MONTGOMERY COUNTY HISTORIC PRESERVATION COMMISSION
STAFF REPORT

Address:	10221 Montgomery Avenue, Kensington	Meeting Date:	6/14/2023
Resource:	Contributing (Primary One) Resource Kensington Historic District	Report Date:	6/07/2023
Applicant:	Bruce Caswell and Lauren Deichman (Mike Roberson/McFarland Woods, Agent)	Public Notice:	5/31/2023
Review:	HAWP	Tax Credit:	N/A
Case Number:	1029631	Staff:	Rebecca Ballo
PROPOSAL:	After the fact demolition of the garage and construction of a new garage

STAFF RECOMMENDATION

Figure 2: Previous garage from 2020; images taken from previous HAWP application from May 2020 looking at the garage from the front, interior of the lot, and the rear elevation, respectively.

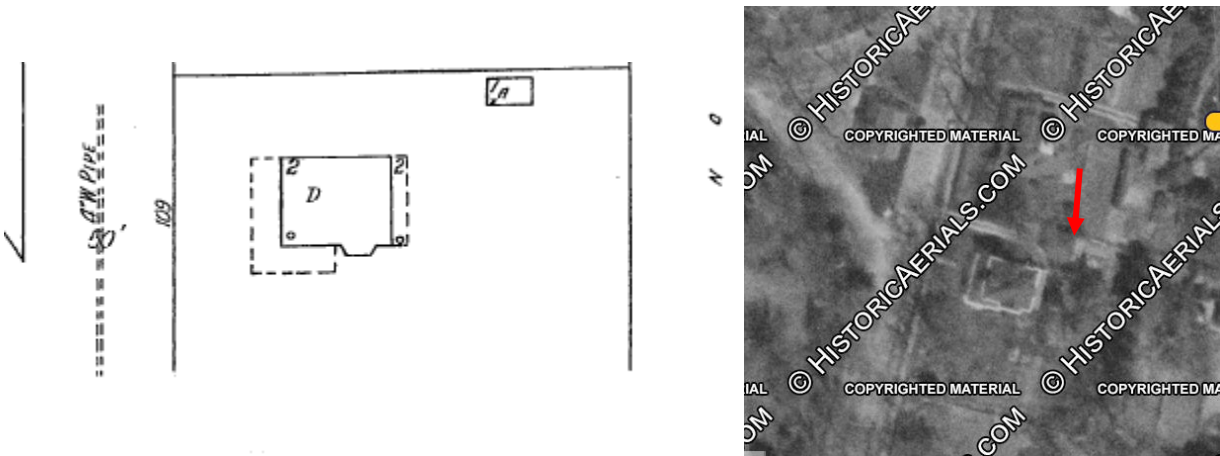
Description of Original Historic Garage

ribbons and a recessed drain had been installed adjacent to the foundation. The original roof had been removed and replaced with an asphalt shingle roof. The existing garage had measured approximately 372 square feet, and 21' 3" deep by 18'4" wide.

Sheet Title
GARAGE ELEVATIONS

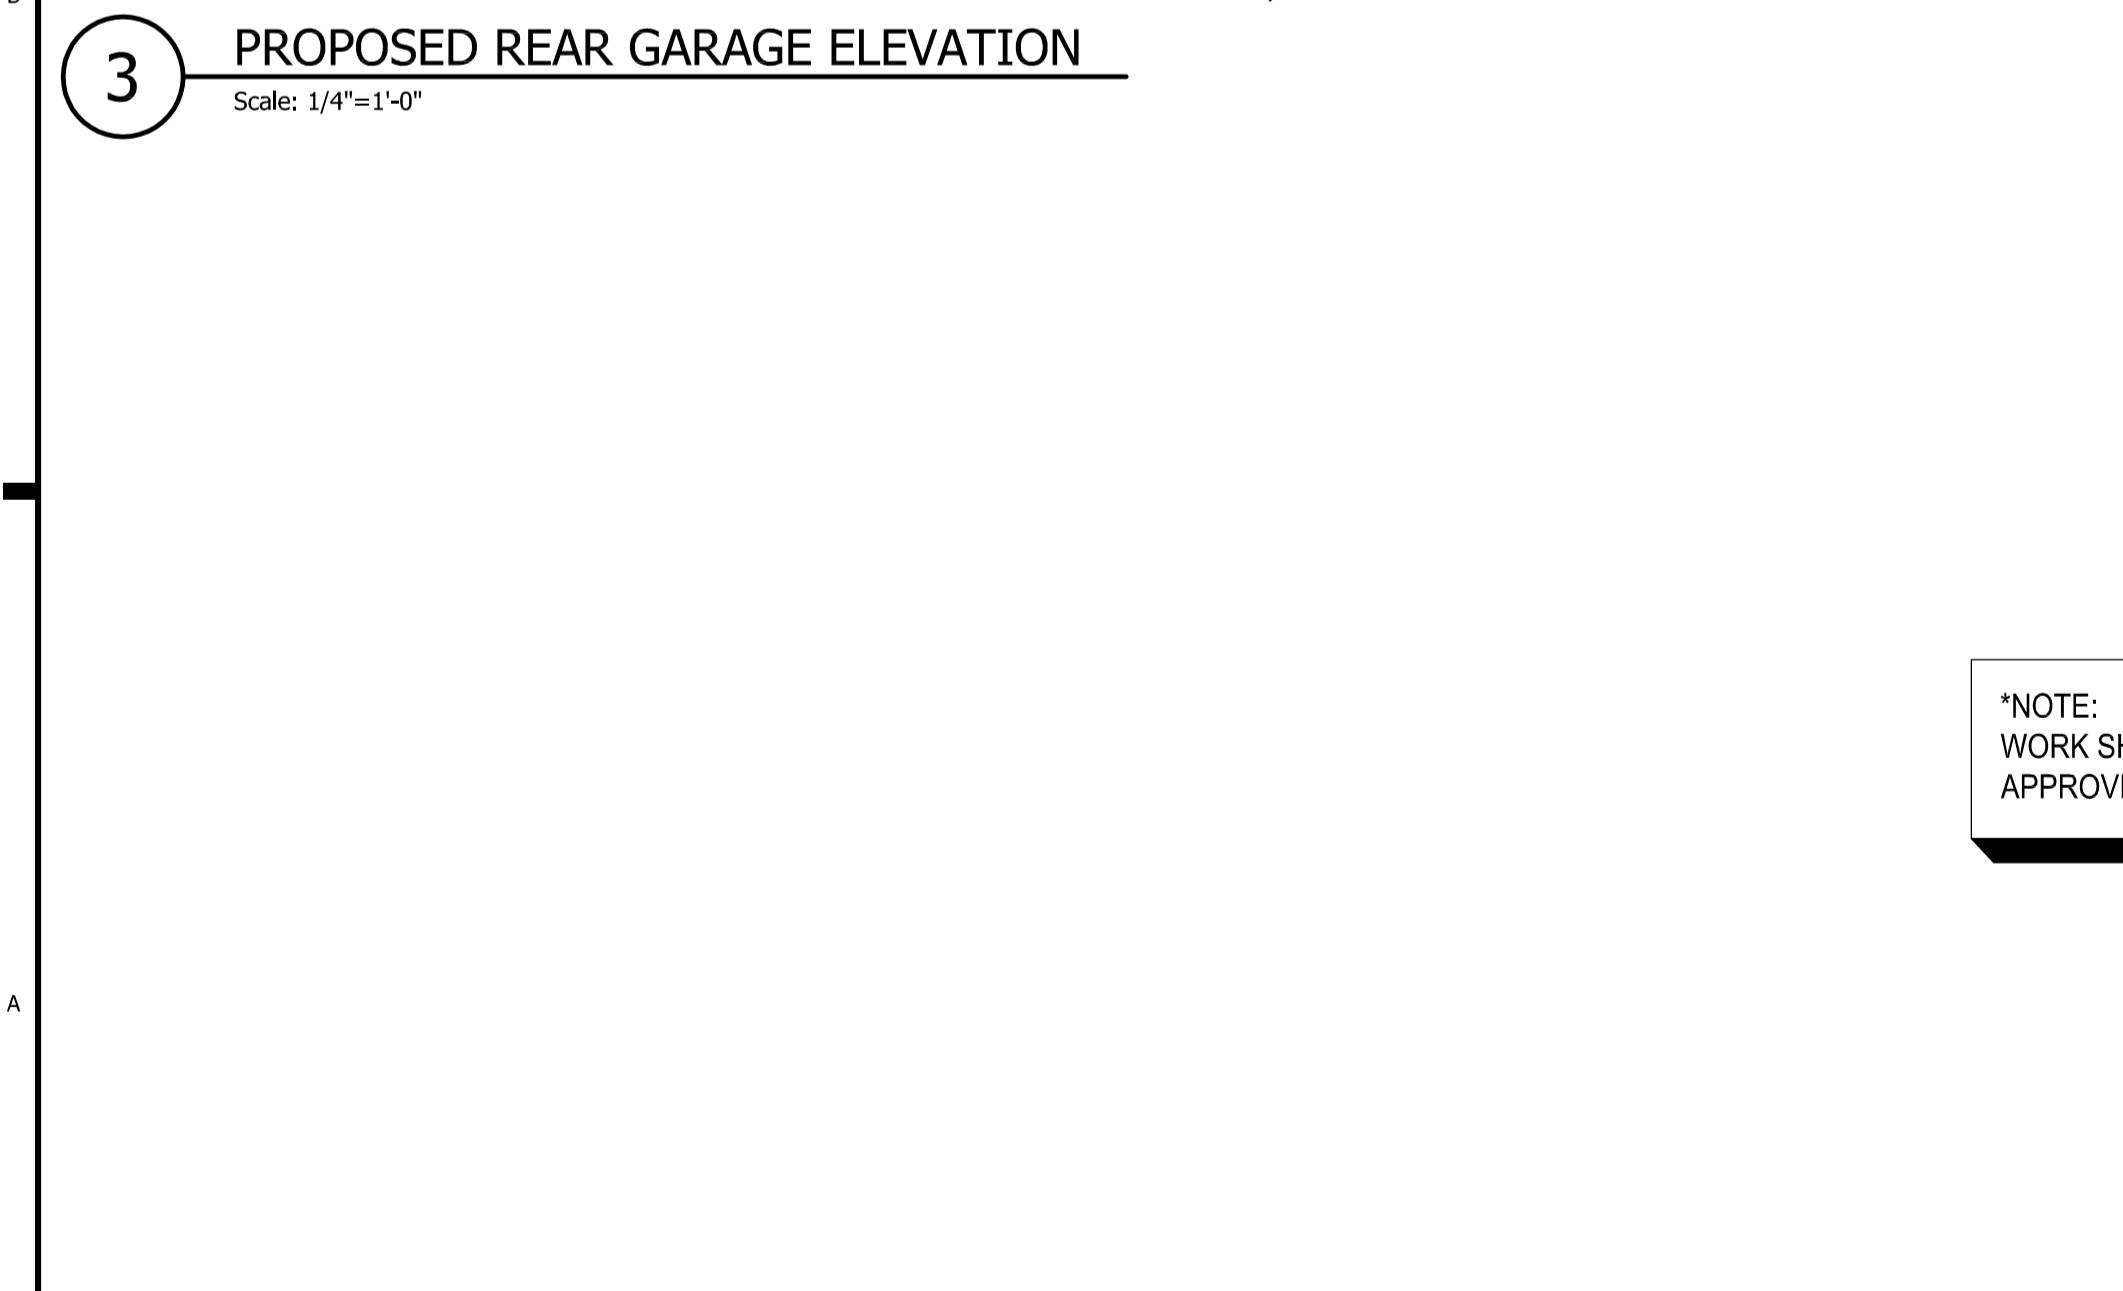
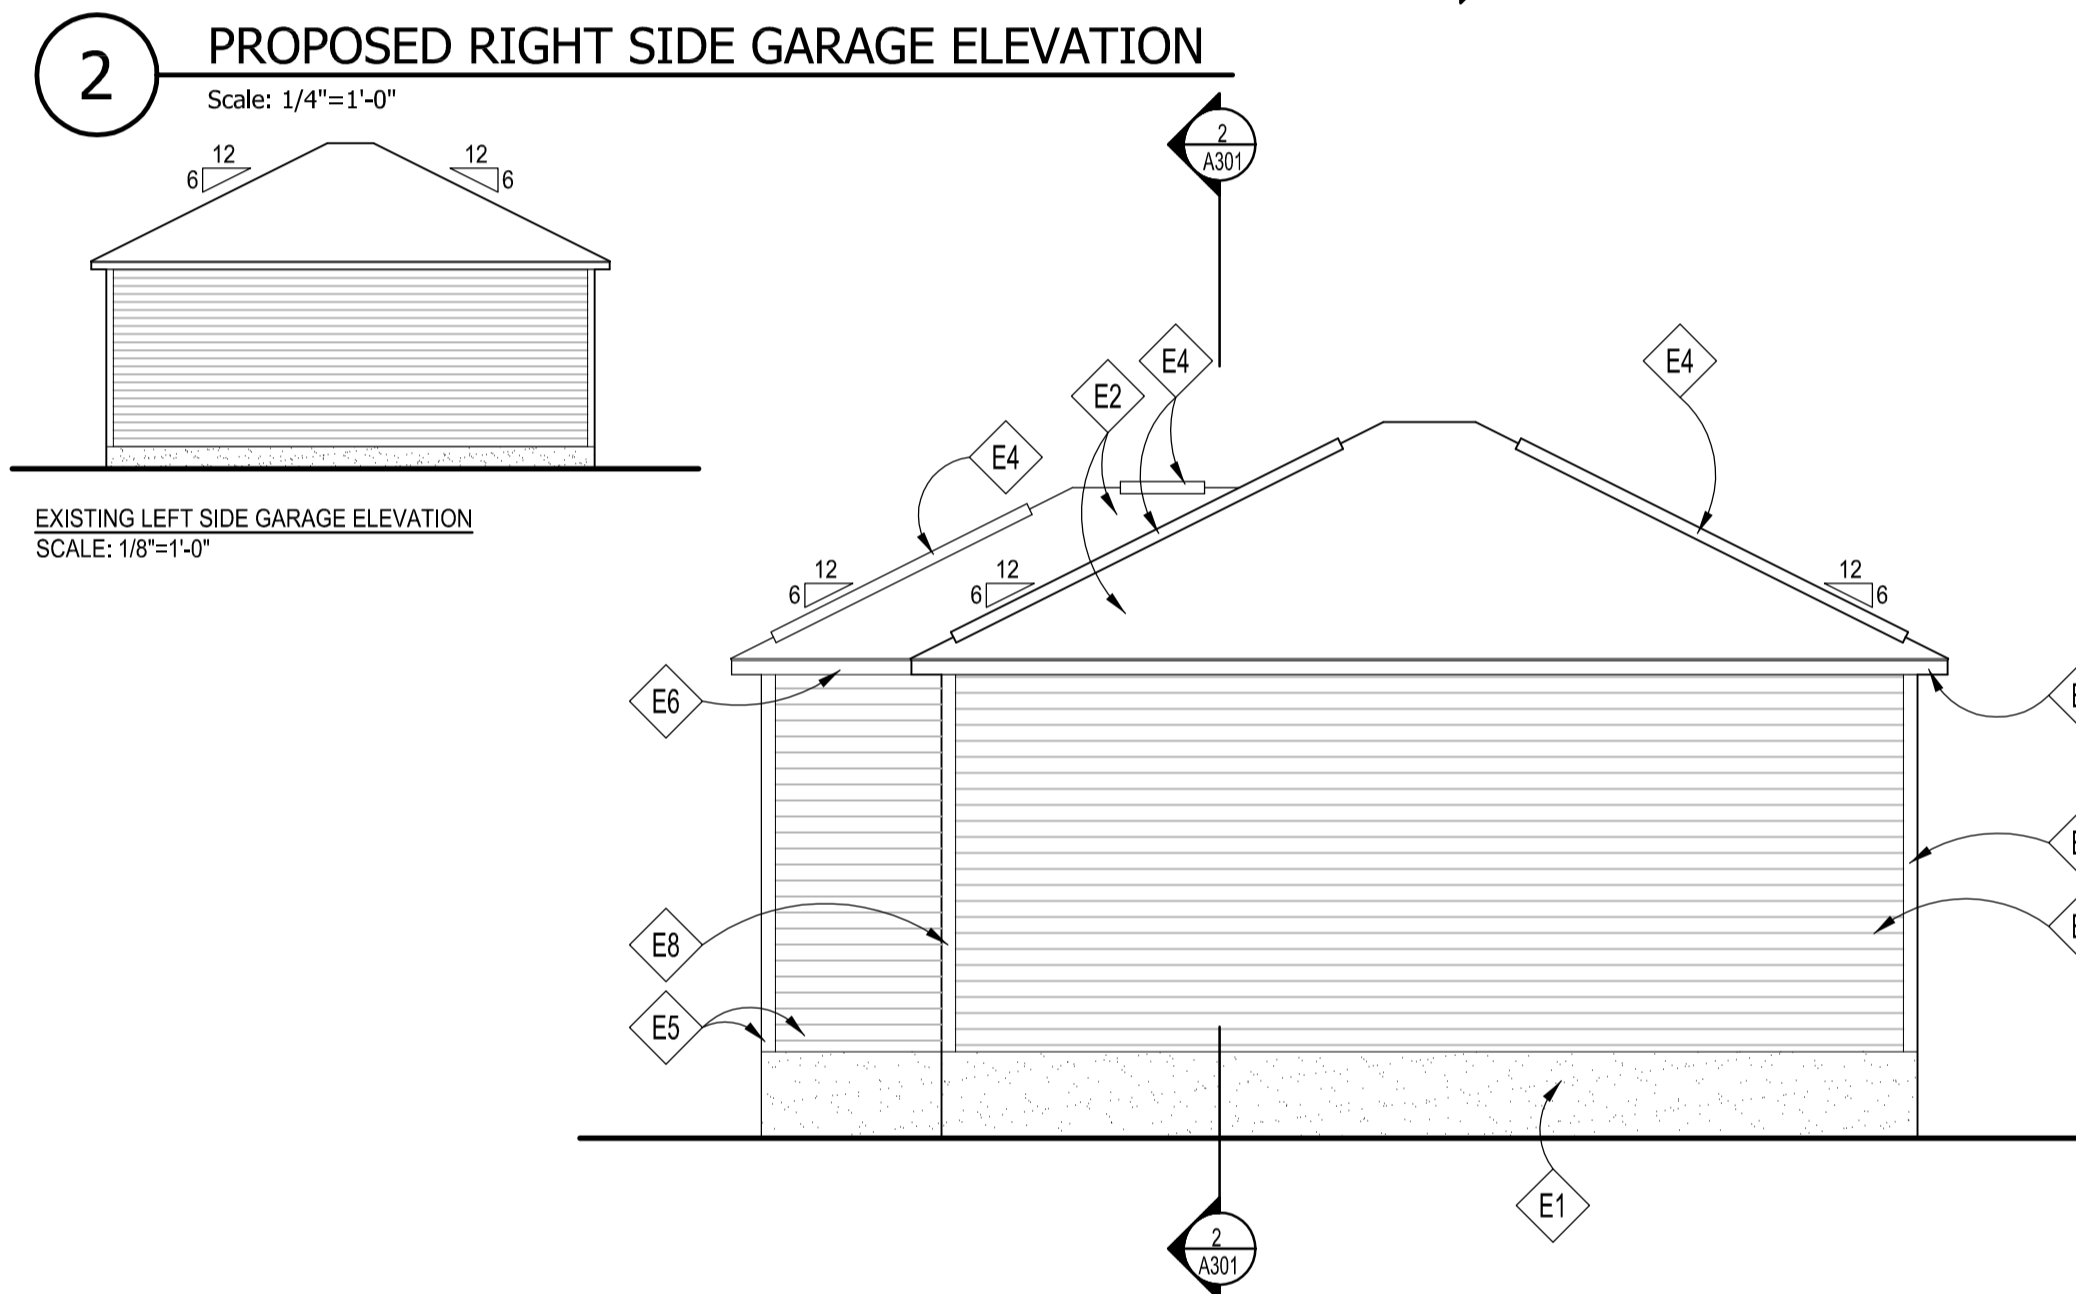
The proposed building will also have an asphalt-clad hipped roof with a 12/6 pitch to match that of the original garage. The proposed garage will rest on a parged CMU foundation, and be clad in painted wood siding to match the original. All material notes on Sheet A200 of the submittal note that all materials will be wood. Notes on Sheet A200, A300 and A301 note that windows and other historic building materials will be reused.

As-built conditions in the field (see attached photographs), however, show that the historic windows were not reused and the single windows in the garage now all have a 1/1 configuration as opposed to the proposed 6/1 from the initial submittal. The garage doors appear to be built as proposed. Other inconsistencies are in the width of the siding—which appears to have a 5"-6" reveal as opposed to the narrower 3"-4" reveal from the original that was proposed to be maintained. The pool equipment that was proposed to be located inside the structure remains on the rear; however it is now exposed and unscreened, whereas the equipment was screened previously. The fascia board beneath the soffit is also more substantial than what previously existed and appears to be several inches taller. In essence, the fine-grained and charming details from the original garage that were once proposed to be retained and replicated with (and which are shown in the submitted drawings), have been removed from the garage that was actually built.

- 2) The single hung windows shall be 6/1 to match those from the demolished garage. The windows may be wood or aluminum clad wood, with simulated-divided-lite spacers. Final details of the windows shall be shown on the revised drawings;

- 3) The siding shall be wood, lap siding, with a reveal no greater than 3”-4”;
- 4) The fascia throughout shall be reduced to have a reveal no greater than 6”;
